Access Compliance Report Public Rights-of-Way (Curb Ramps)

Intersection ID: 46915 Main Street: RAISIN_TREE_LN Cross Street: PONDEROSA_PINE_LN Location: NW

ADA ID: 9453E70C82ED Ramp Type: PerpDiag Initial Pass/Fail: Fail Overall Compliance: No Severity Score: 25

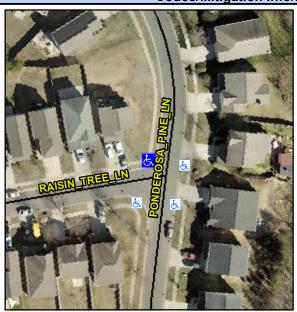
R304.2.2, R304.5.3

Compliance Description		Data	Compliance Description		Data
N/A	Ramp Length (in)	48.0	No	Ramp Slope (%)	9.9
Yes	Ramp Width (in)	48.0	No	Ramp XSlope (%)	5.1
N/A	Flare Type LT	N/A	N/A	Flare Type RT	N/A
N/A	Flare Slope LT (%)	N/A	N/A	Flare Slope RT (%)	N/A
N/A	Flare Traversable LT?	N/A	N/A	Flare Traversable RT?	N/A
N/A	Landing Length (in)	N/A	N/A	DWS Provided?	N/A
N/A	Landing Width (in)	N/A	N/A	DWS Contrast?	N/A
N/A	Landing Slope (%)	N/A	N/A	DWS Length (in)	N/A
N/A	Landing X Slope (%)	N/A	N/A	DWS Full Width?	N/A
N/A	Landing Curb? (Y/N)	N/A	N/A	DWS Offset (in)	N/A
N/A	Shared Landing?	N/A			
N/A	Gutter Ponding?	N/A	N/A	Gutter Slope (%)	N/A
N/A	Gutter Lip Ht (in)	N/A	N/A	Gutter X Slope (%)	N/A
N/A	Painted X Walk1?	No	N/A	Painted X Walk2?	No
	X Walk 1 Direction	To S		X Walk 2 Direction	To E
N/A	X Walk 1 Width (in)	N/A	N/A	X Walk 2 Width (in)	N/A
	X Walk 1 Slope (%)	3.7		X Walk 2 Slope (%)	4.6
	X Walk 1 X Slope (%)	1.0		X Walk 2 X Slope (%)	2.1

Remove & Replace Curb Ramp With Two New Directional Ramps or Equivalent.
